Project	IEEE 802.16 Broadband Wireless Access Working Group < http://ieee802.org/16 >	
Title	Revision of Hand-over Mechanism for Mobility Enhancement	
Date Submitted	2003-10-30	
Source(s)	Phillip Barber Broadband Mobile Technologies, Inc. 8302 Sebastian Inlet Frisco, Tx 75035	Voice: +1 (972) 365-6314 Fax: +1 (925) 396-0269 [mailto:pbarber@BroadbandMobileTech.com]
Re:	Response to IEEE 802.16e-03/23 (Call for Contributions on IEEE 802.16e/07r4) Response to Session 27 Minutes remand C802.16e-03/54r0 to Ad Hoc Group for refinement and continued revision	
Abstract	Clarification, revision, and definition of Hand-over mechanism for Mobility Enhancements	
Purpose	Stimulate discussion on a more completely defined, flexible model and mechanism for facilitating mobility functionality	
Notice	This document has been prepared to assist IEEE 802.16. It is offered as a basis for discussion and is not binding on the contributing individual(s) or organization(s). The material in this document is subject to change in form and content after further study. The contributor(s) reserve(s) the right to add, amend or withdraw material contained herein.

Revision of Hand-over Mechanism for Mobility Enhanceme

[In Annex D.2, page 61, replace Figure D.10 with:]

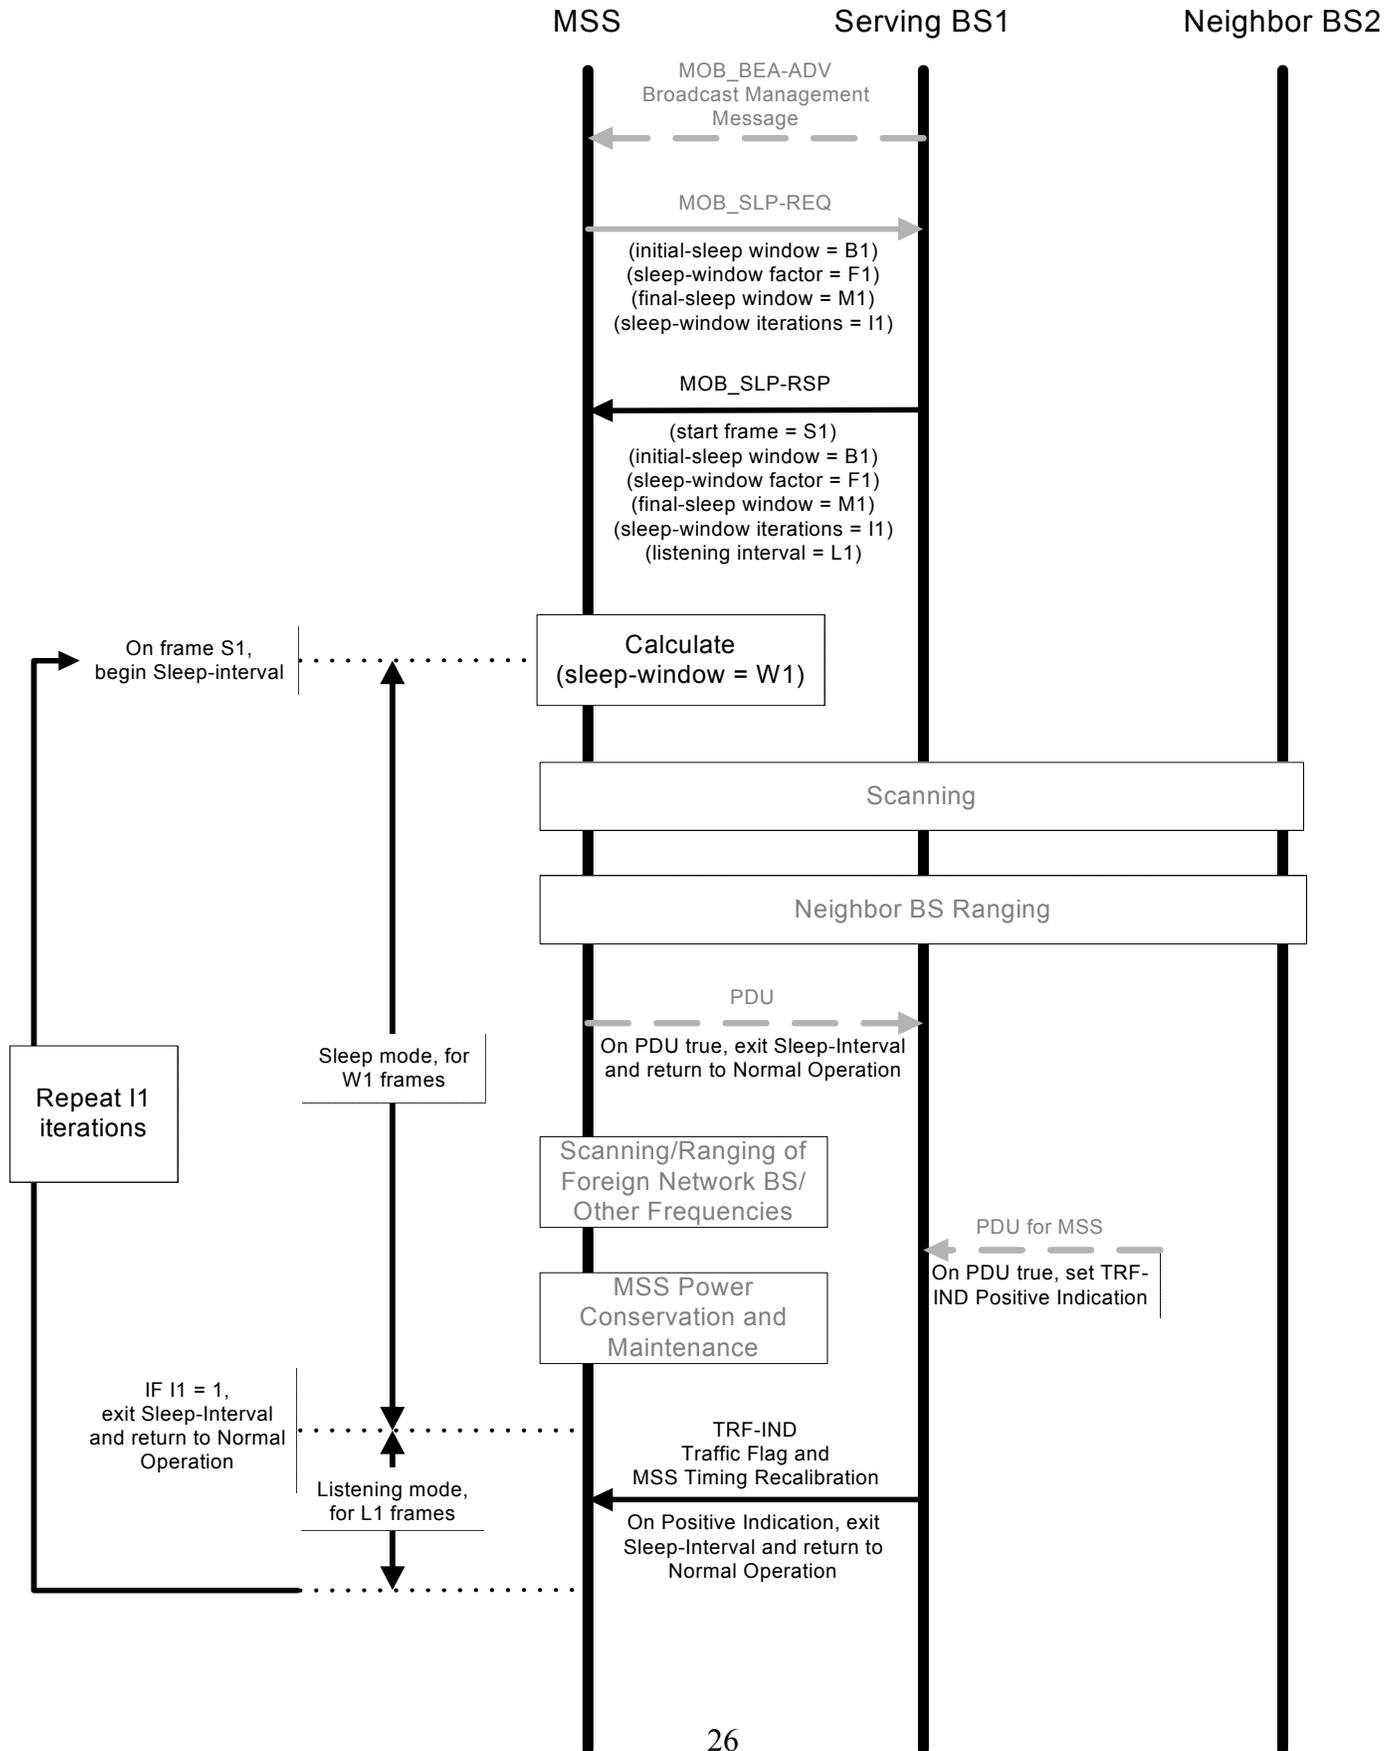
*[In Annex D.2, pages 62 & 63, delete **Figures D.11 and D.12** entirely]*

Figure C.1—Example of HO Process Flow

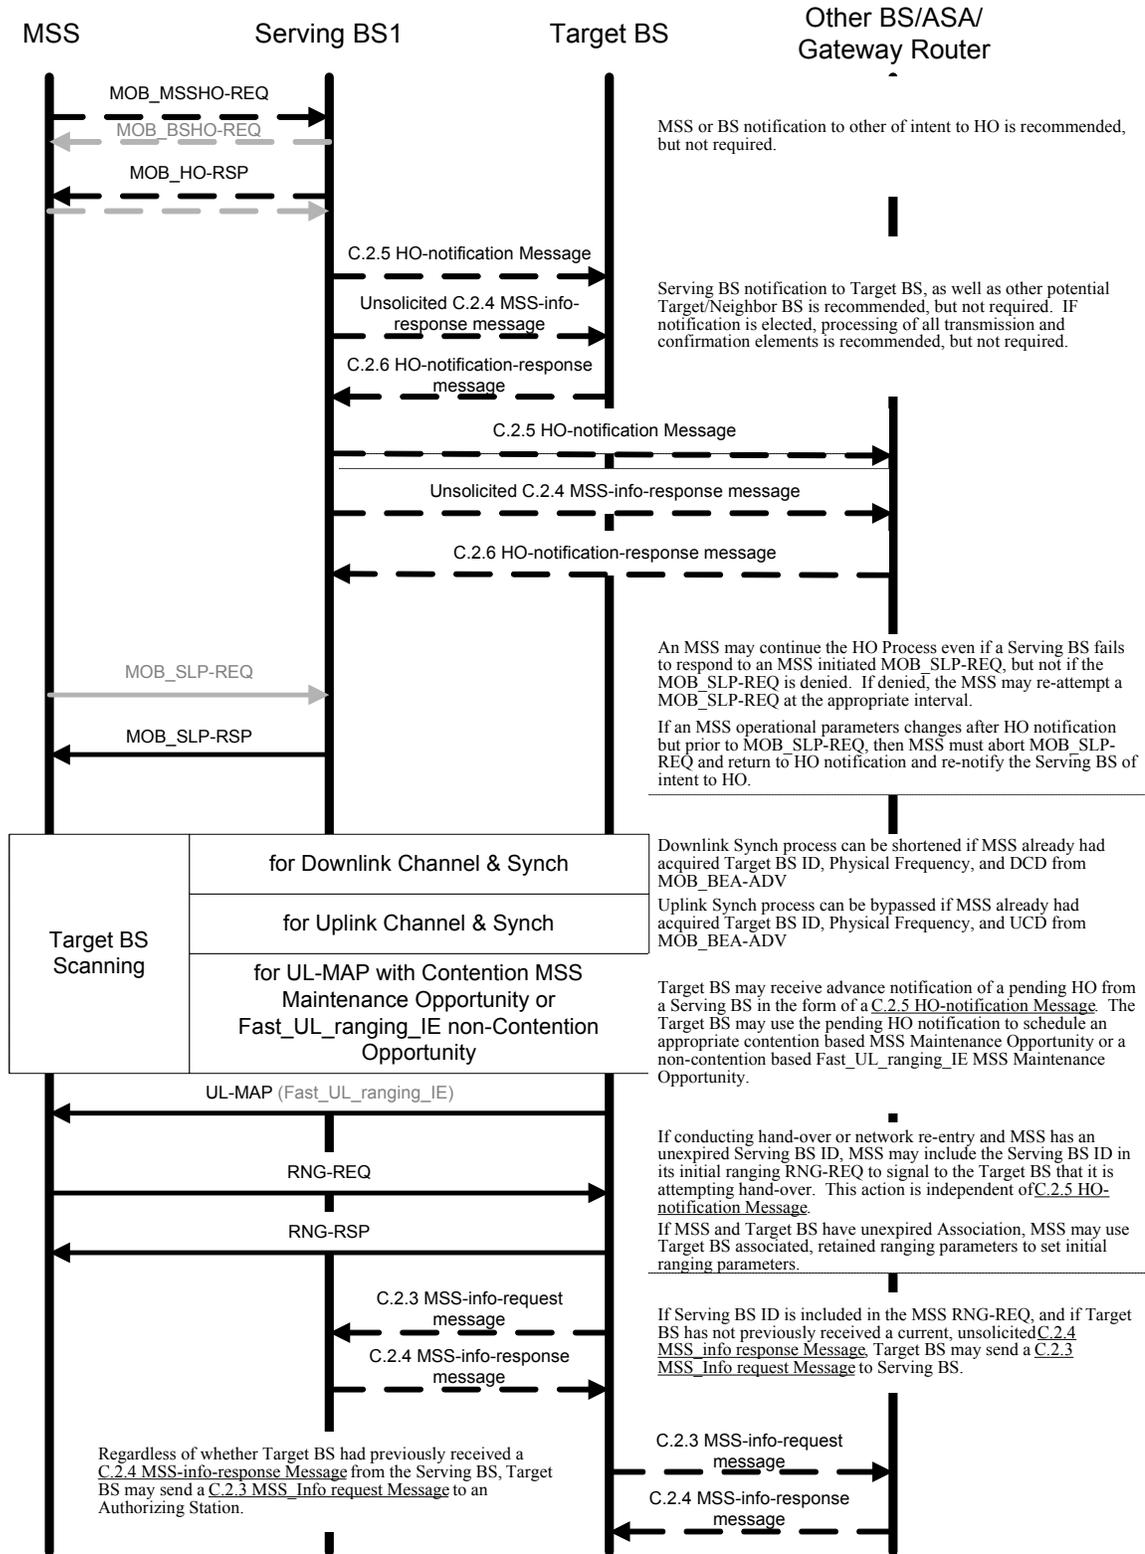
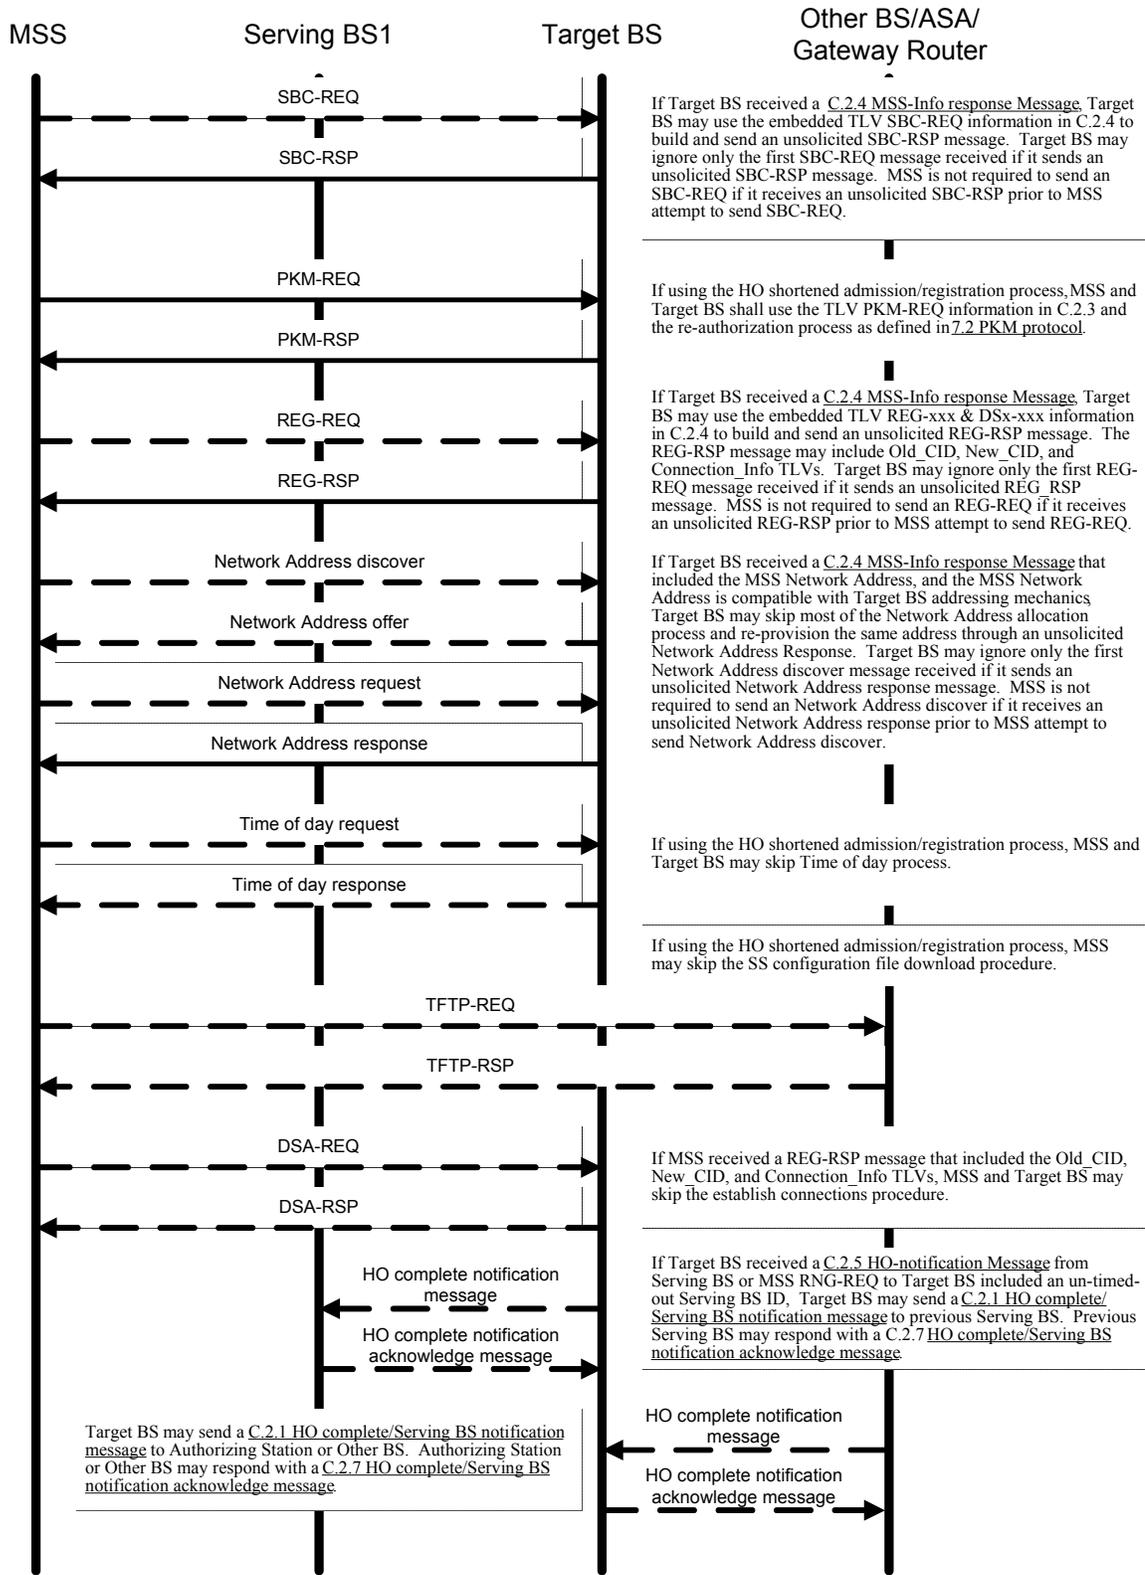
[In C.2.8 Example of Backbone Network HO procedure, pages 48-50, delete Figure C.2—Example of HO call flow by BS entirely and replace Figure C.1—Example of HO call flow by MS with:]

Figure D.10—Sleep mode

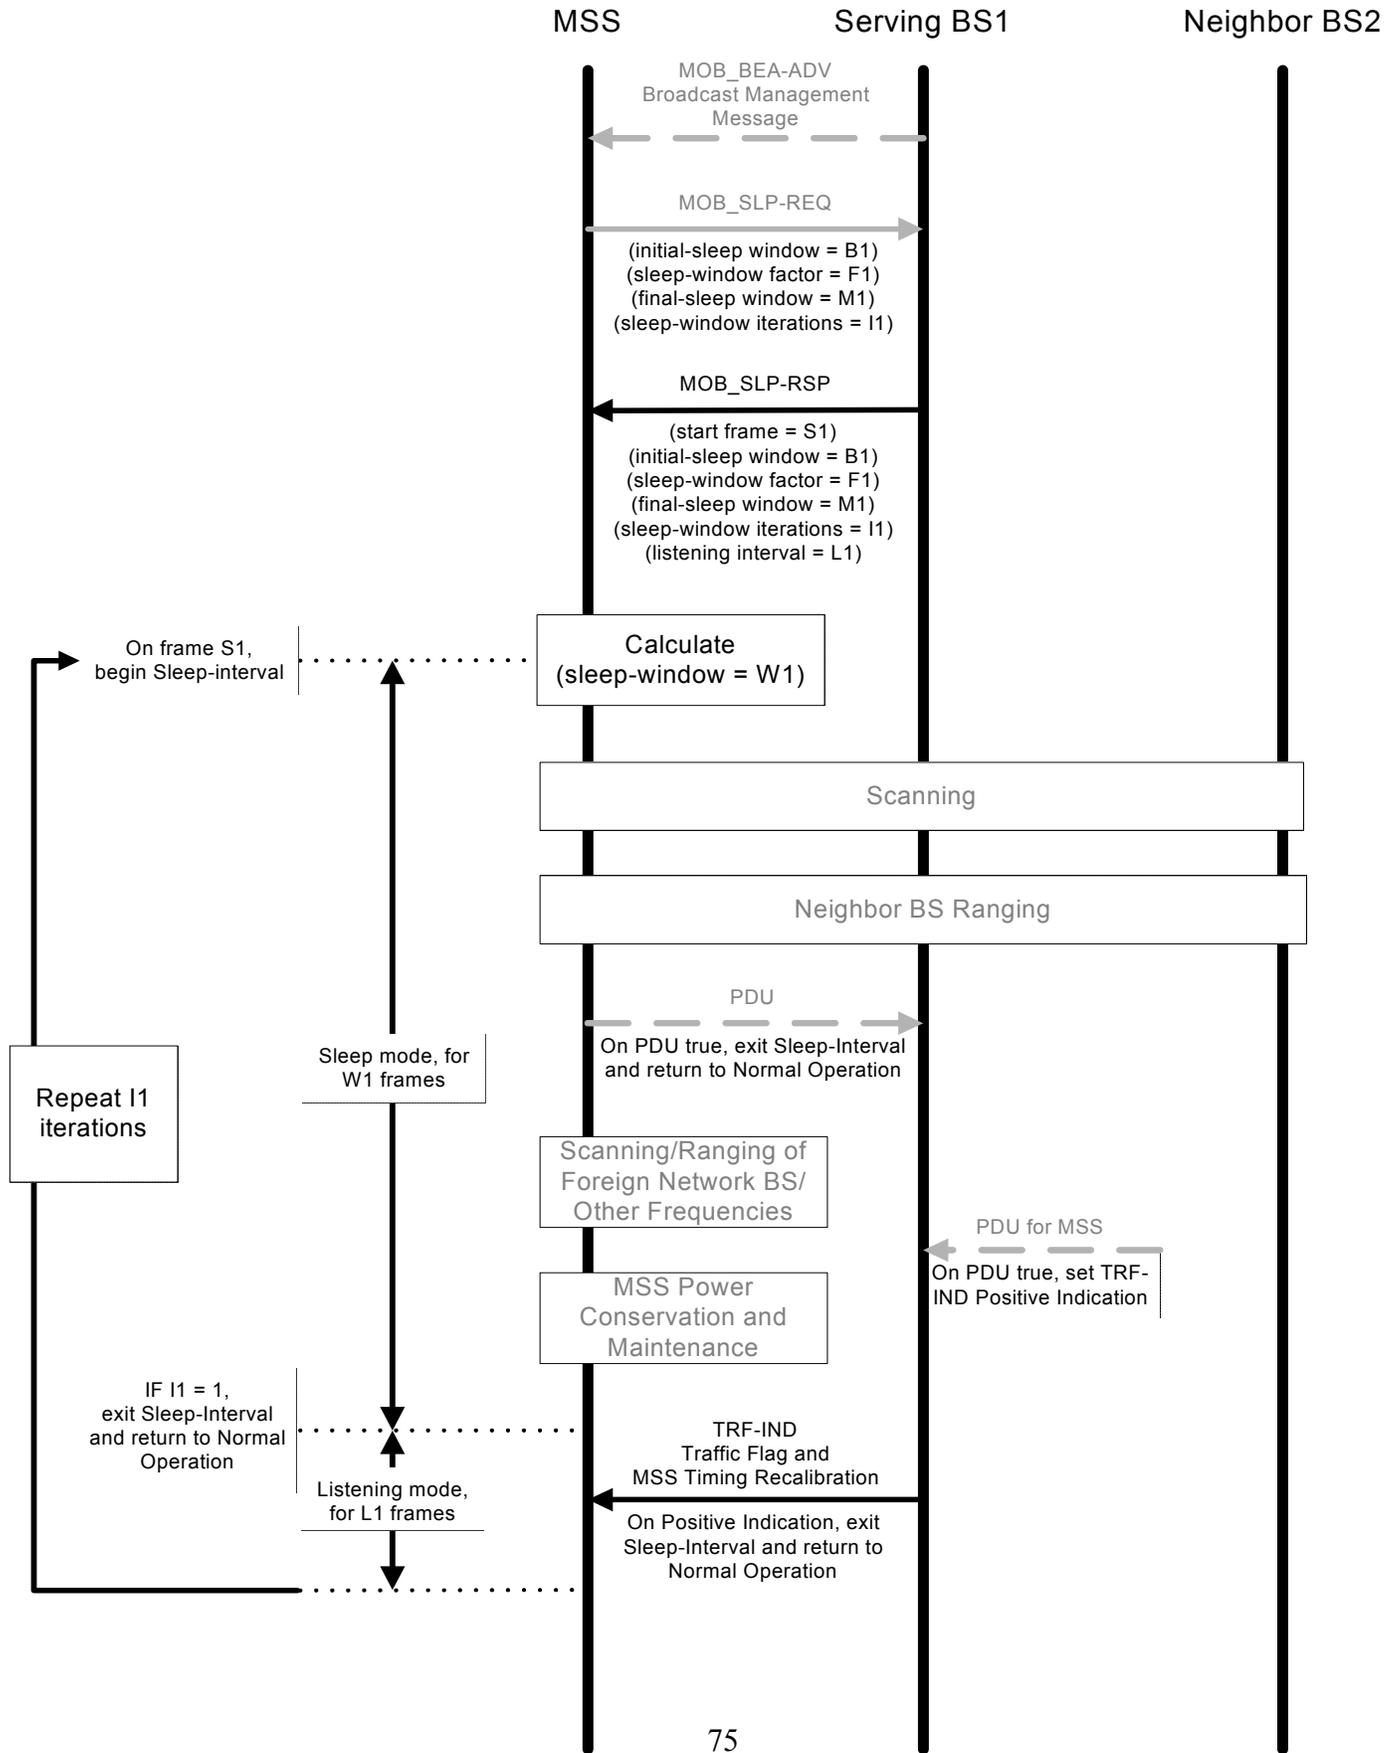
*[In Annex D.2, page 61, replace **Figure D.10, D.11, and D.12** entirely with:]*
